**Attachment B:
Pre-application Design Review**

Subject: Summary of Tim Wolff Pre-application Design Review meeting with the Planning and Zoning Commission, May 29, 2012

WOLFF MIXED USE DEVELOPMENT
APRIL 24, 2012
OLSON KUNDIG ARCHITECTS

EAST ELEVATION (FROM EAST AVENUE)

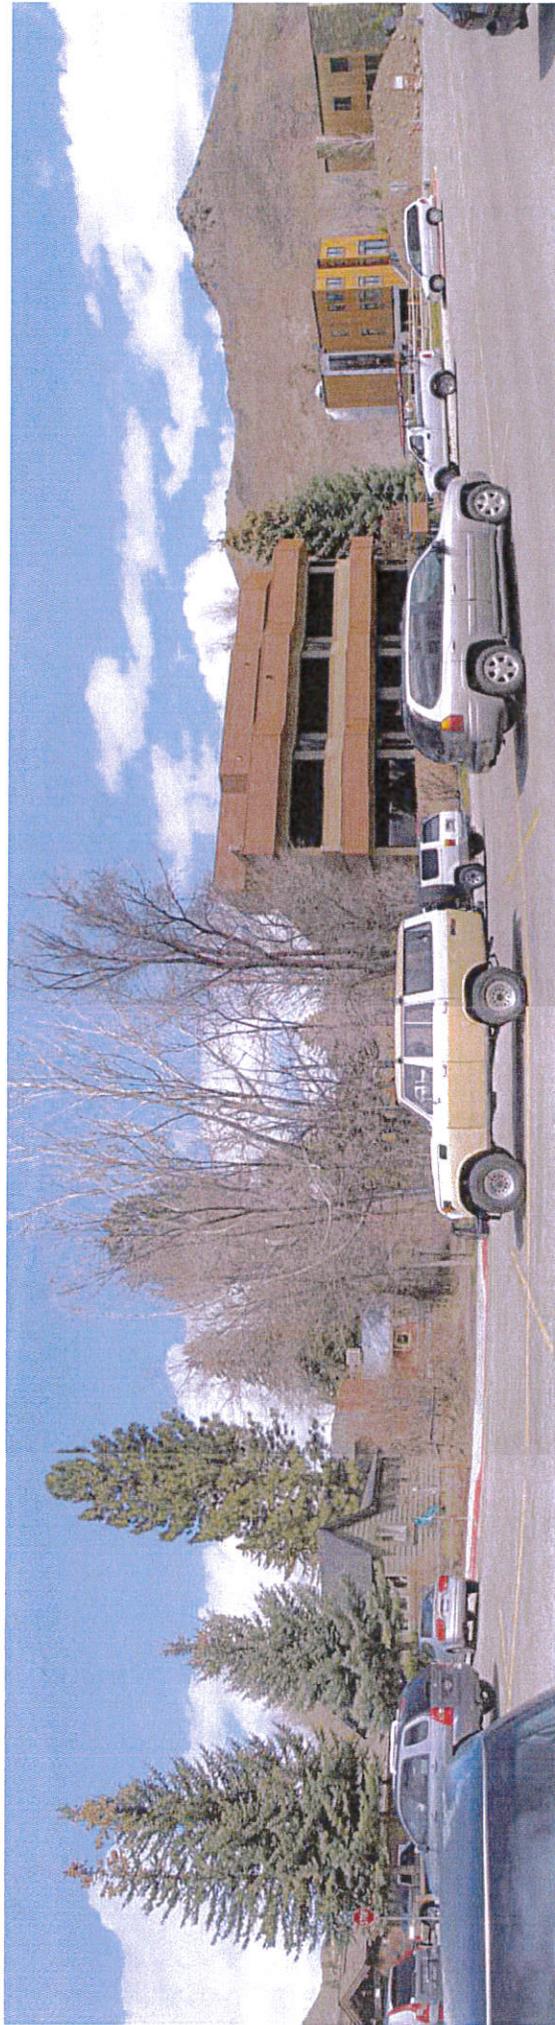
- Windows – The number of windows on the East Avenue façade needs to be increased to the required 60%.
- Sign – Sign master plan to be provided at Design Review.

- While the City would like to see a 10 foot wide sidewalk, current code only requires 5 feet. The Commission would like to see a more detailed plan at Design Review for the sidewalk and landscaping at the front of the property.
- Although the code says that sidewalks shall be heated, that section of the code can receive exemptions. The Commission agreed that the sidewalk would not need to be heated, but that a detailed maintenance plan must accompany the Design Review application.
- A Signage Master Plan will be required at Design Review.
- The Commission felt that the ground floor entry alcove was too small and needed to be more generous.
- The applicant shall increase the window area on the front façade to meet the minimum 60% glazing to façade area ratio.
